**Re: Main Street Waterlines (PR#45-2025)**  
**City of Carlton (PWS ID#00171)**  
**Conditional Approval**

Thank you for your submittal on March 21, 2025 of the Tetra Tech technical memorandum entitled *City of Carlton – PWSID# 4100171 Main Street Sanitary Sewer and Water Main Replacement Project OHA PRE-CONSTRUCTION PLAN REVIEW SUBMITTAL March 2025*, plans, and specifications for the waterline replacement project in the City of Carlton. This project, assigned plan review # 45-2025, is not associated with a subdivision or new development, therefore a Land Use Compatibility Statement (LUCS) is not required. A plan review fee payment in the amount of \$3,300 was requested on March 25, 2025 (payment pending and required prior to Final).

This project (Tetra Tech Project #200-13914-24001-36) involves replacing approximately 1,300 lineal feet of existing 4" diameter water main with new 8" and 12" AWWA C900, DR 18 PVC water main in the City of Carlton's water distribution system.

**Table 1: Water Distribution Main Design Parameters**

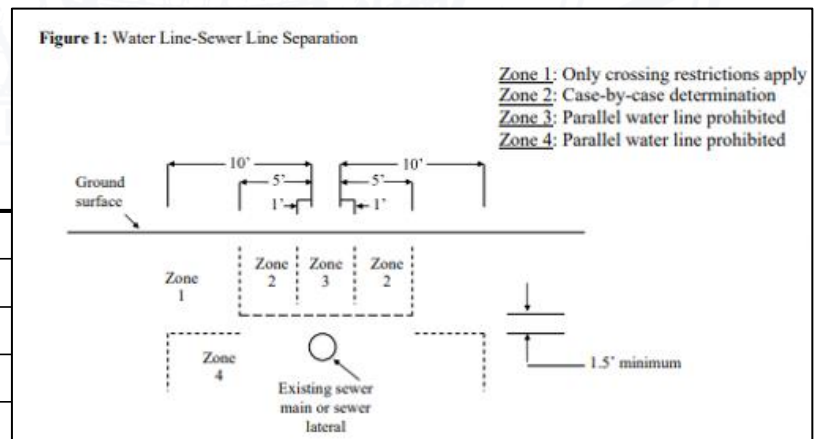
1. All items in contact with potable water must meet NSF Standard 61 or equivalent.
2. The design must allow for 20 psi to be maintained at all service meters.
3. Water and sewer line crossings conform to construction standards under OAR 333-061-0050(9). Waterlines running parallel to newer lines must also meet OAR 333-061-0050(9) – see enclosure. The April 2025 Construction Documents did not specify sewer/waterline separations. It is not clear how the utility separation requirements in Table 1 of the technical memorandum and the general water construction notes in Drawing G-002 meet these construction standards. Drawings did appear to show adequate vertical separation with waterlines falling in Zone 1 per Figure 1 of OAR 333-061-0050(9) shown below.
